MICROLIGHT AIRWORTHINESS APPROVAL NOTE

MAAN NO:1762

ISSUE 2

TITLE: Microlight Airworthiness Approval Note 1762, Crosbie replacement undercarriage for CFM Shadow aircraft (all microlight variants). Also increase in maximum permitted empty weight and modification to the maintenance manual to include mandatory nosewheel inspection.

Isometric view showing packer profile to suit any side pod ply wood already removed

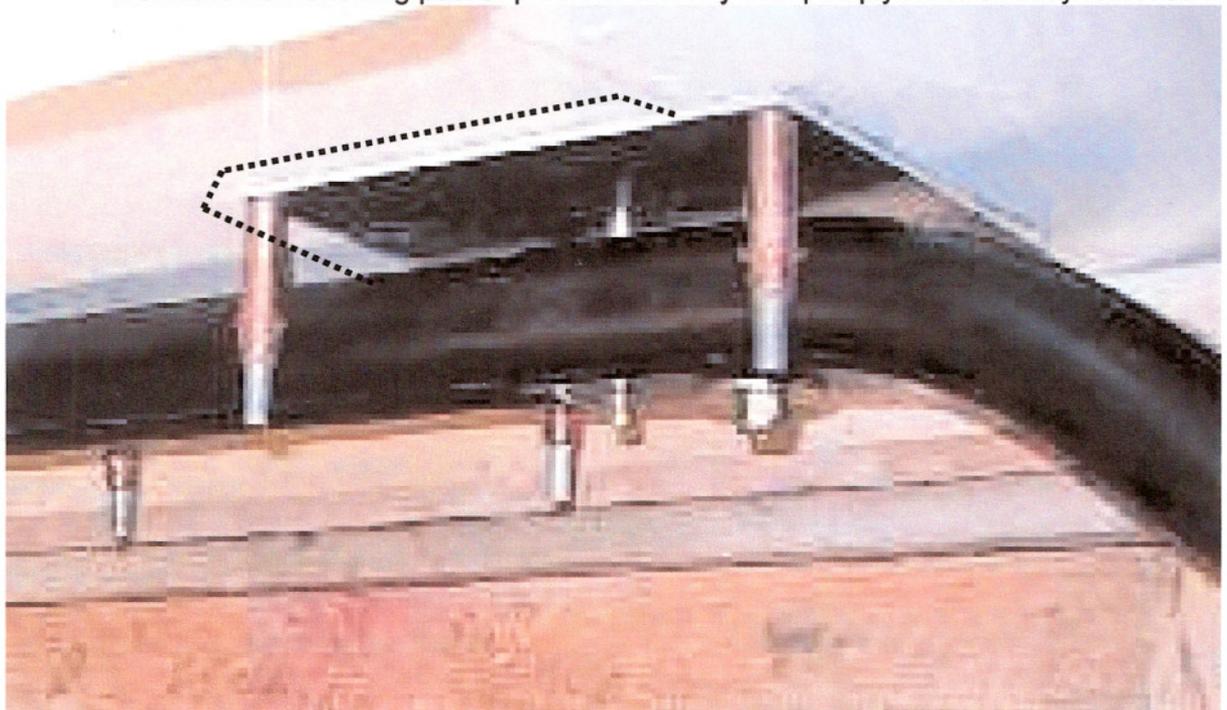
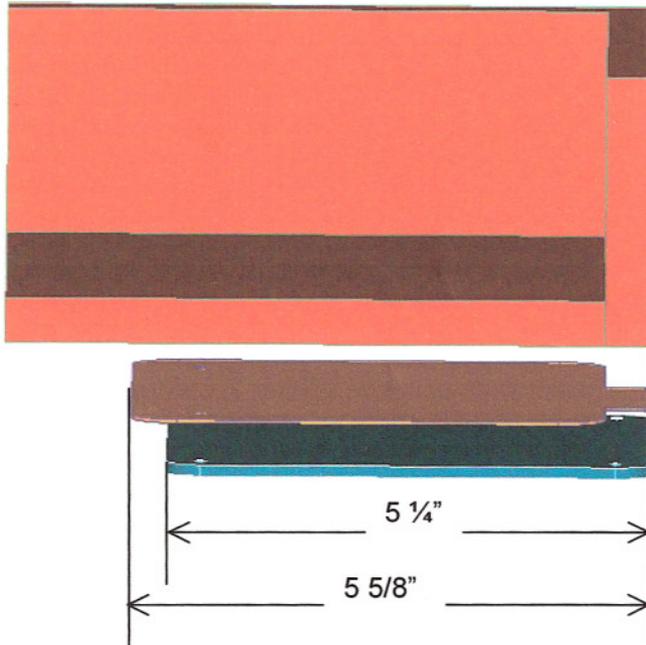
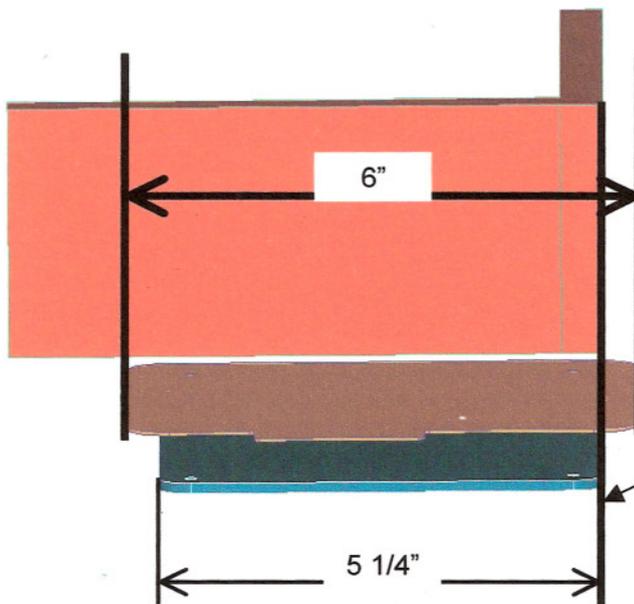
This addendum to the original worksheet requires that a 1mm aluminium packer is fitted, between the new 5.25" square plates and the fuselage floor, allowing the bottom plates to sit over the side-pod ply wood flange and therefore negate the requirement to remove any more of the side-pod plywood.

plywood bulkhead with packing by a 1mm aluminium plate. This does not remove approval for previous version of this modification, but alters the approved basis for all future fitments of the Crosbie undercarriage. This is shown in Appendix C.
